ADA Curb Ramp New Construction Inspection Form (Parallel)

Nw 314th ave

24952.54

Nw. Kaybern st

PARALLEL RAMP (PL)

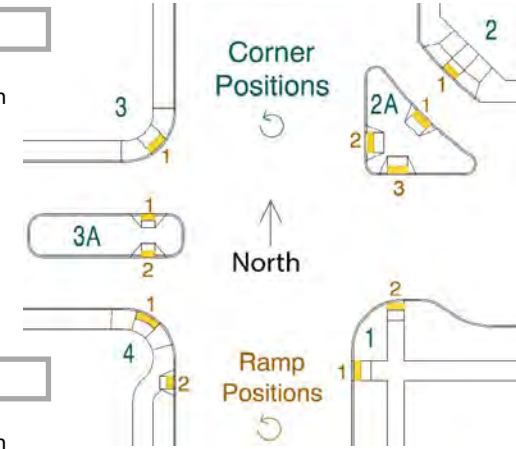
10.5 $\leq 2.0\%$ ☐ $> 2.0\%$ ☒

2.5 $\leq 2.0\%$ ☐ $> 2.0\%$ ☒

N Y ☐ N ☒

☐ 21.05 $\leq 8.3\%$ ☐ $> 8.3\%$ ☒

No truncated dome, no RR2 or RR3
